FLOOR PLAN

7501 N. MANHATTAN
TAMPA, FLORIDA 33614

PERMIT NUMBER:
P1701273

A1.0

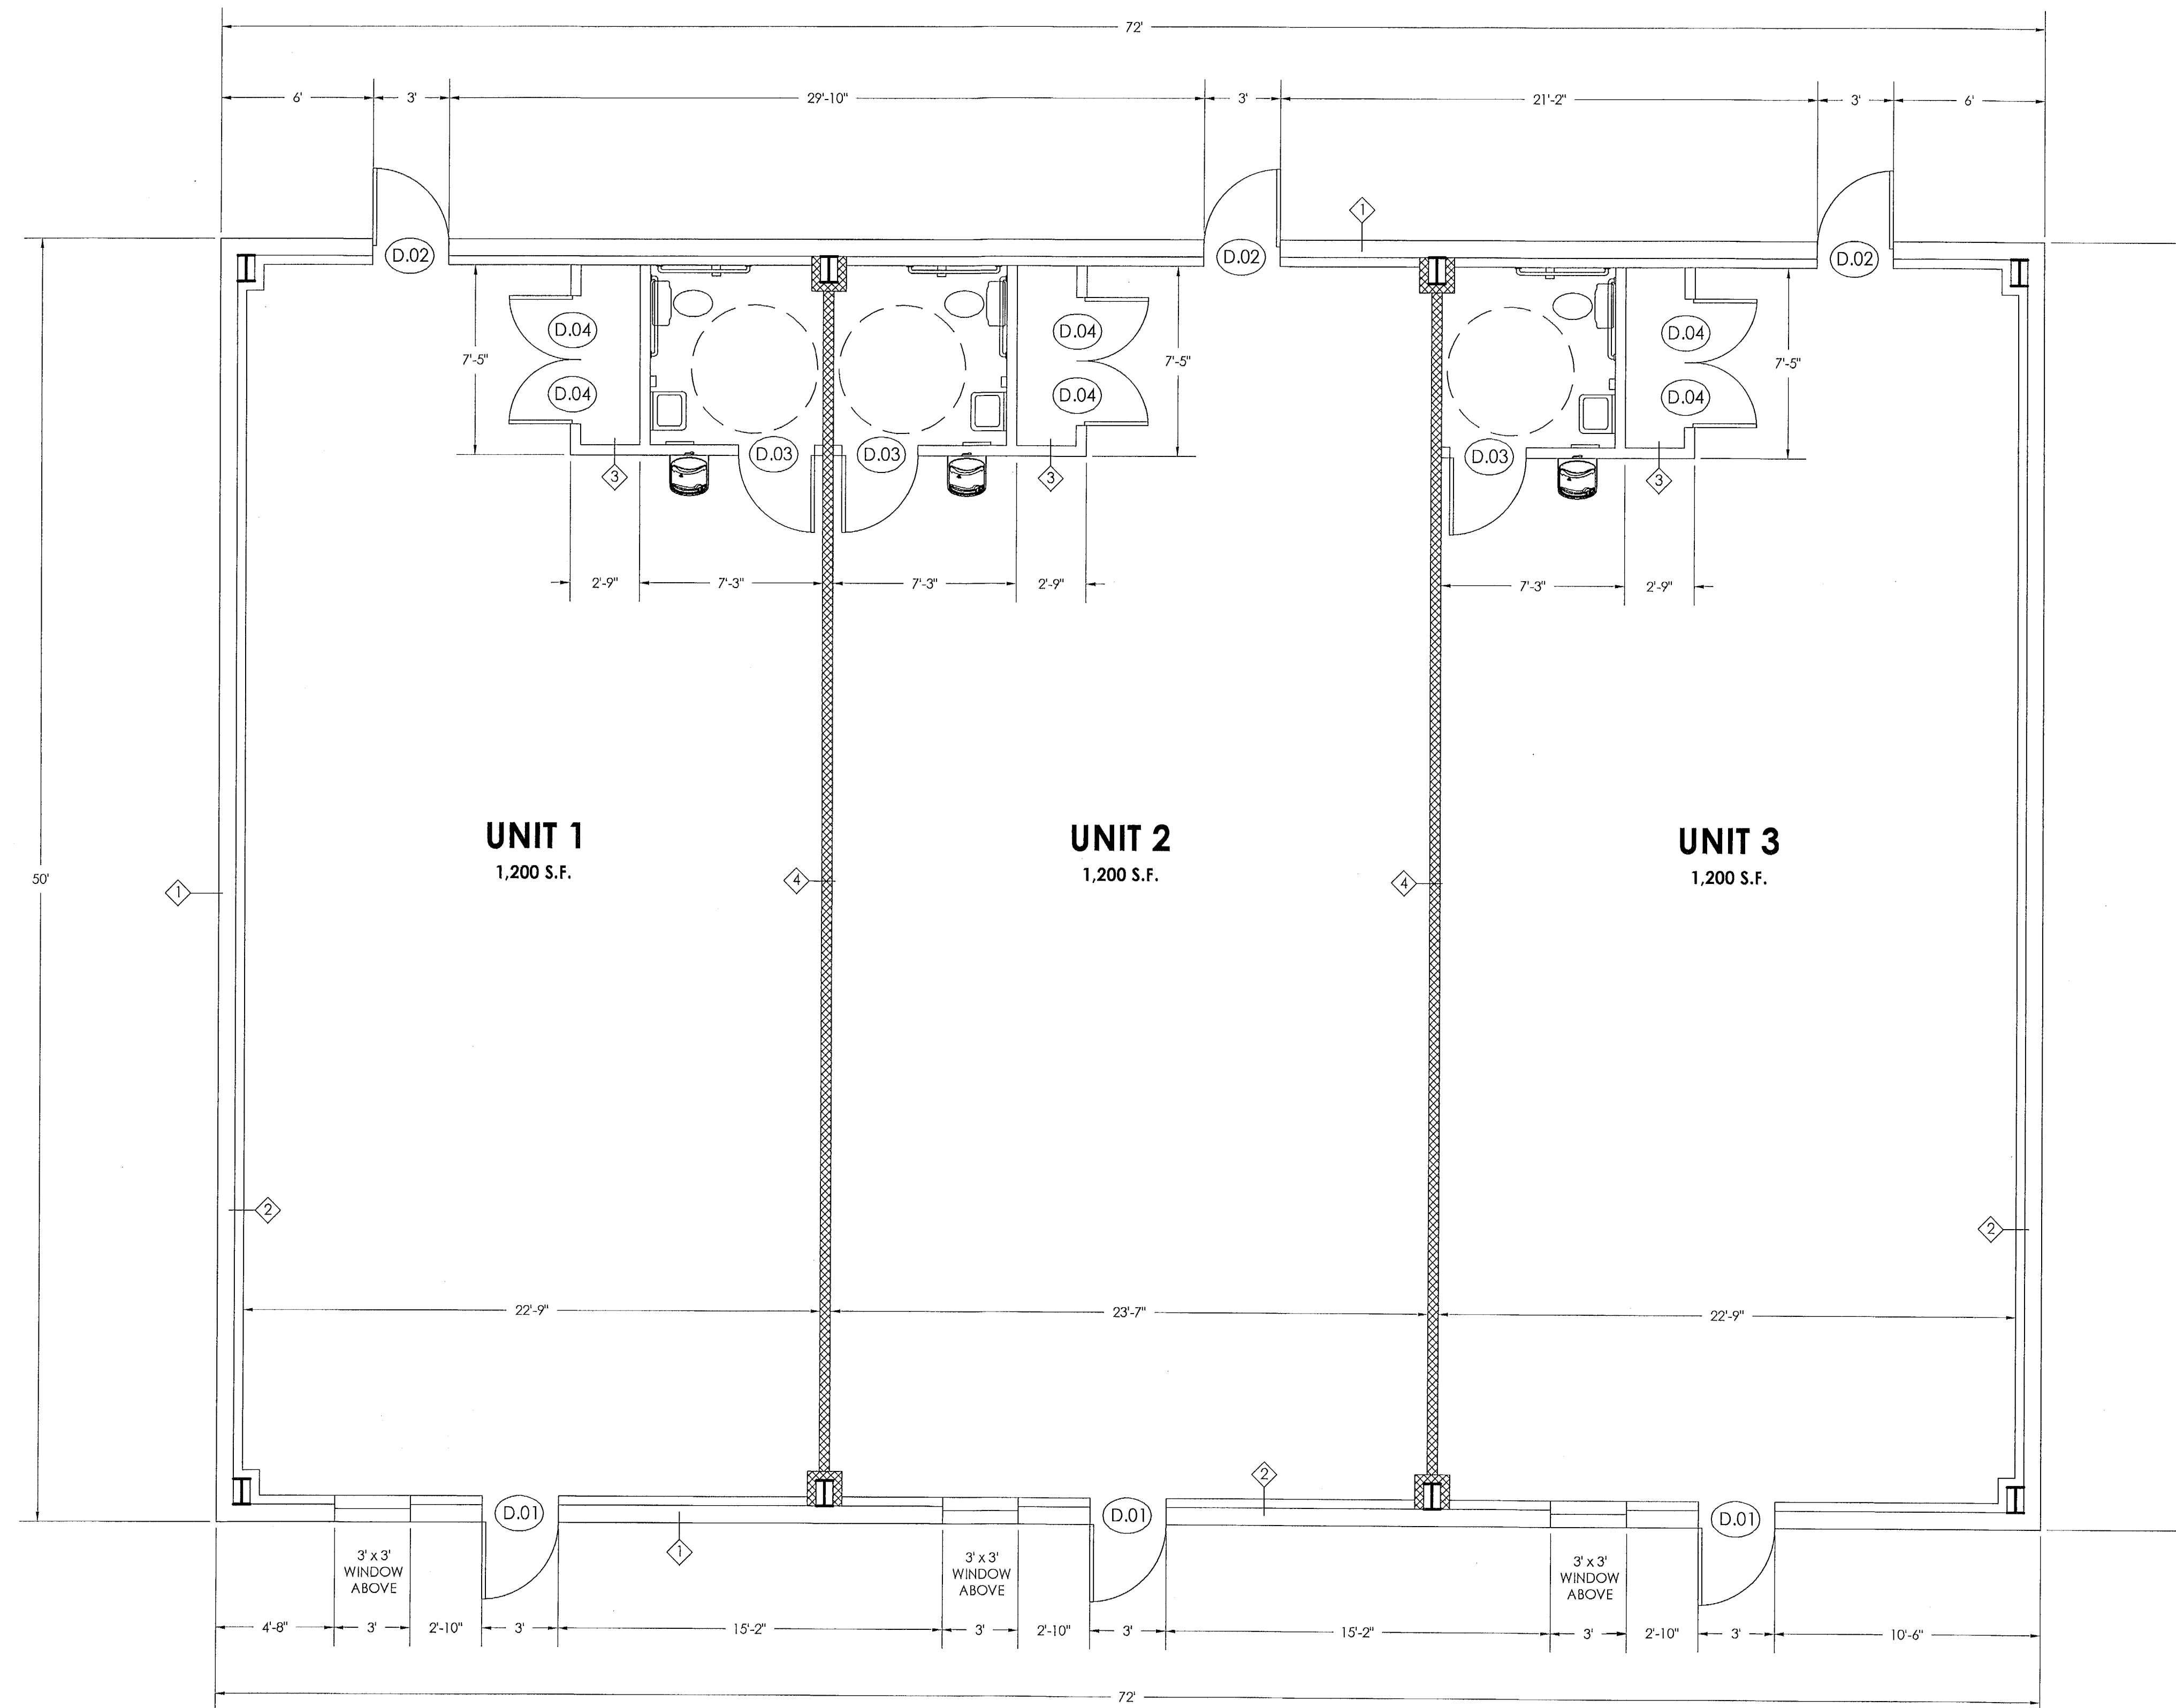
NO.	DATE	REVISIONS
1	7/30/18	COMMENTS
		#4 PART. WALL REVISED TO 2 HR FW

MARK	DESCRIPTION
1	METAL BUILDING EXTERIOR WALL, 8-INCHES FROM OUTSIDE TO INSIDE OF PURLIN
2	3-5/8" METAL STUD AGAINST INSIDE OF METAL BUILDING & 5/8" GYP. BOARD PAINTED ON ONE SIDE
3	INTERIOR PARTITION WALL, PER DETAIL "TYPICAL WALL SECTION" SHEET A0.1
4	2-HOUR FIRE RATED PARTITION WALL, PER DETAIL (2) SHEET A0.1
